The Corporation of the District of Saanich

To: Mayor and Council
From: Sharon Hvozanski, Director of Planning
Date: June 1, 2021
Subject: Development Permit Amendment
File: DPA00965 • 3100 (3120) Tillicum Road

Figure 1: Proposed Site Plan (from plans by Iredale Group Architecture)

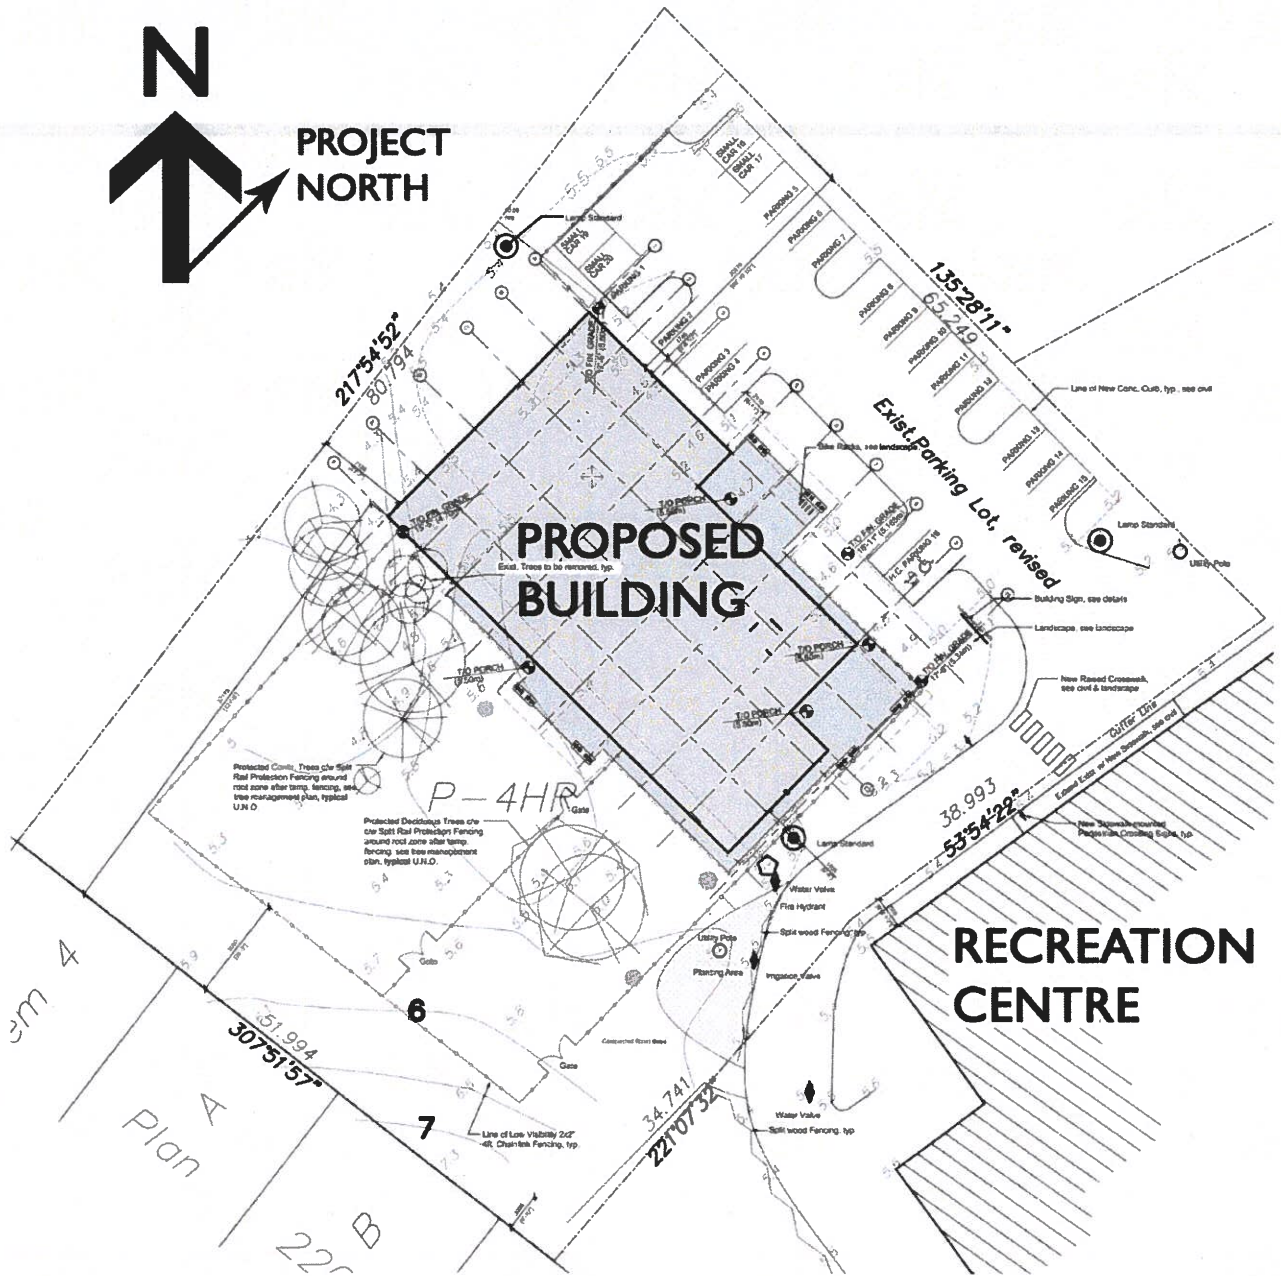
The applicant has also provided a landscape plan and additional details for the use of the land at the rear of the proposed daycare for play areas. The applicant states that their intention is to retain as many of the healthy trees as possible, which is why they have relocated the stormwater retention tanks, removed the proposed stroller parking, and are flexible in the placement of the fencing to limit tree removal.

Tree # 661, a 24 cm DBH Garry Oak and surrounding trees proposed for retention are now shown on the landscape plans. The landscape plans show a "compacted road base" note adjacent to these trees. During the onsite meeting this area was discussed and the applicant's team committed to installing an access path to the play area in such a way that it would not require any tree removals and be built to minimize all impacts to retained trees. This will be a condition of any further tree permits for the site and can be field fit under arborist supervision at the landscape and construction stage of the development.

The proposed Garry Oak planting sites on the west side of the building adjacent to the stormwater detention tanks appear too close to the building to meet the Bylaw replacement criteria. In addition, the current area is filled with blast rock and the applicant's landscape plan has not indicated if soil volume, sufficient to grow trees, will be remediated in this area. During the onsite meeting the applicant's team committed to remediating the planting area to meet Saanich tree planting specifications. Parks recommends that all tree planting sites and specifications are addressed on landscape as-built plans at the end of construction for a record of the site. As no bonding was taken for this project, this would need to be secured by covenant and has been included in the recommendation.

- 1. That Development Permit Amendment DPA00965 be approved.
2. That prior to final ratification of the Development Permit Amendment, the applicant register a covenant to secure the provision of all tree planting sites and specifications on landscape as-built plans at the end of construction for a record of the site.

Figure 2: Elevations as per Approved Development Permit (from plans by Iredale Group Architecture)

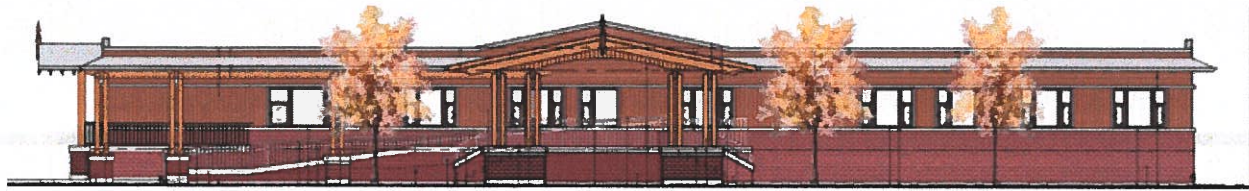
The previously approved one-storey building has an area of 722 m². The design of the building was originally based on modular construction, where modules constructed elsewhere would be brought to the site and set on concrete footings and pilasters. To allow for plumbing, electrical, and other services to be located in the crawlspace, the floor height was to be located approximately 1 m above grade. Additional architectural elements such as porches, gables, stairs, and ramps were proposed to provide access and to help soften the modular look (see Figure 2).

The applicant submitted revised drawings to Building Inspections Services. The revised Building Permit drawings moved away from the modular design approach and instead proposed a building to be constructed on-site. The applicant has indicated that the change in construction methodology was based on their recent findings that the modular approach would have been more expensive than on-site construction. As a result, the proposed crawlspace below the building has been eliminated and the applicant has constructed the building lower to the ground, removing the need for the steps and ramps (see Figure 3).

The original Development Permit also called for natural cedar siding. To reduce long-term maintenance costs, the applicant has substituted the natural cedar siding for Hardie board siding that would mimic the look of cedar and be stained to match the colour of natural cedar.
